June 11, 2013

**Re: Docket No. 07-SB-1; Comments on the Cost Effectiveness of Rooftop Solar Photovoltaic Systems for Consideration in California's Building Efficiency Standards**

## Projections of Cost per Installed Watt - 2020

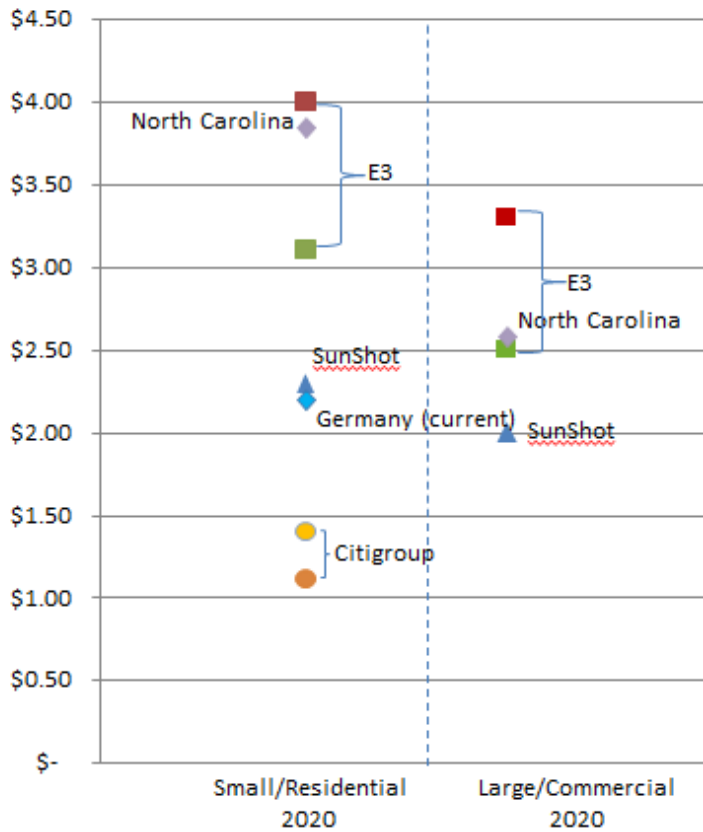
Given the data that show what can be achieved today with best practices, the draft report's predictions for the future appear fairly conservative. A number of other studies also point to the reasonableness/conservativeness of E3's projection of solar installed costs:

The "Projections of Cost per Installed Watt- 2020" graph below compares the different estimates identified above. Collectively these studies' estimates suggest that E3's analysis is relatively conservative and thus, justified and reasonable for purposes of its cost-effectiveness analysis.
